# NEC Microcomputer Technical Information

<p>V853 32-Bit Microcontrollers Usage Restrictions</p>	Document No.	ZBG-CC-05-0074	1/1
	Date issued	December 15, 2005	
	Issued by	Solution Development Group Multipurpose Microcomputer Systems Division 4th Systems Operations Unit NEC Electronics Corporation	
<p>Related documents</p> <p>Hardware User's Manual: U10913EJ6V0UM00 (6th edition)            Architecture User's Manual: U10243EJ7V0UM00 (7th edition)            Data Sheet (mask ROM): U13188EJ6V1DS00 (6th edition)            Data Sheet (flash memory): U13189EJ5V1DS00 (5th edition)</p>	Notification classification	√	Usage restriction
			Upgrade
			Document modification
			Other notification

V853, V853A

### CSI Communication Mode with Handshake Supported (MSB-first transfer)

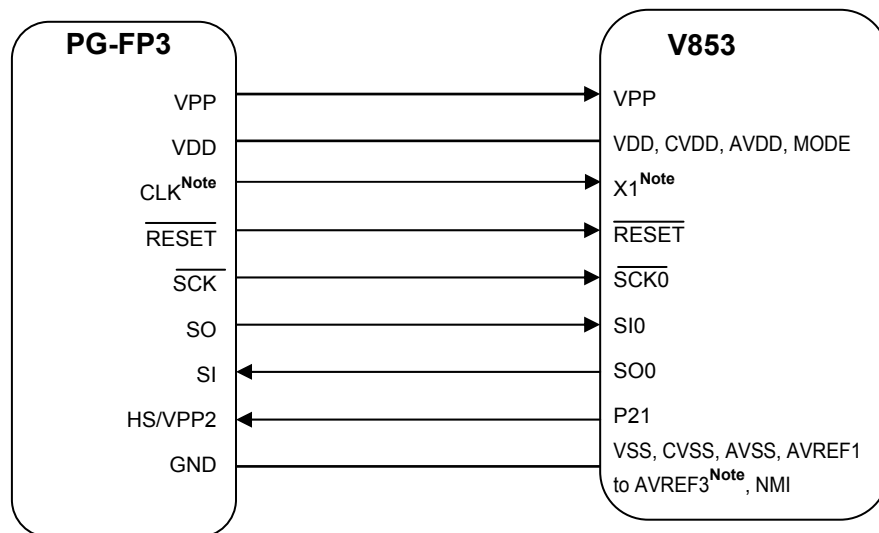
**Caution** There is basically a separate parameter file for each rank. The parameter file for X rank products cannot be used when writing products with M rank (other than K, E, P or X), because the programming process is different. Be sure to change the parameter file in accordance with the rank.

The  $\mu$ PD70F3025A (rank M) and  $\mu$ PD70F3003A support high-speed flash memory programming using a 3-wire serial handshake mode. The PG-FP2 is not supported.

- (1) Directly connect the HS pin (or Vpp2 pin) of the target interface of the NEC Electronics flash programmer PG-FP3 to pin 21 of the device.
- (2) Change the COMM PORT setting to SIO ch-3+handshake on the GUI (host PC).
- (3) Start programming.

**Interrupt Source That Can Trigger A/D Conversion**

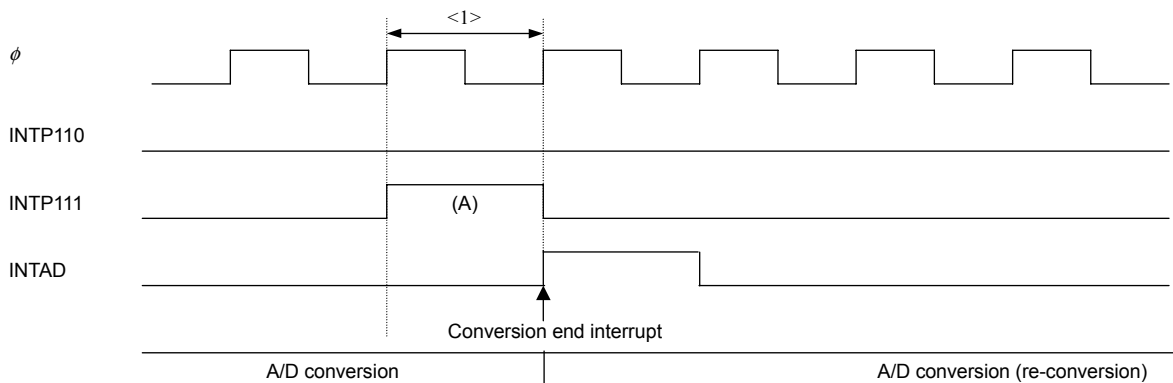
If a timer match interrupt (INTCC111, INTCC112, or INTCC113) or an external pin interrupt (INTP111, INTP112, or INTP113) occurs when the 1-trigger mode of the timer trigger mode or external trigger mode is used, A/D conversion may be re-started after A/D conversion ends.

Originally, only INTCC110 can be the trigger to start the A/D converter in the 1-trigger mode, and ADTRG pin input in the external trigger mode, therefore the interrupt sources listed below should be ignored. However, if one of the interrupt sources listed below occurs immediately before the end of A/D conversion (<1> in the figure below; 1 internal system clock), it is mistakenly judged as the A/D conversion start trigger. As a result, A/D conversion is started again after the A/D conversion end interrupt (INTAD) is issued. The first A/D conversion ends correctly and the result is stored in the ADCRn register (this value can be read during the second conversion).

**Caution** The external interrupt signal that functions alternately as the external capture trigger input of timer 1 can also be a trigger for re-conversion. In the case of an external interrupt input, this restriction applies when a valid edge is input before the timing of (A) in the above figure by the noise eliminator (digital noise elimination (2 to 3 internal system clocks)).

- (1) Start A/D conversion in the A/D trigger mode by setting the ADCE bit of the ADM0 register to 1 in the interrupt service routine of the timer match interrupt or external pin interrupt.
- (2) Do not use the compare match interrupt (INTCC111/112/113) and external interrupt signal (INTP111/112/113) during A/D conversion.
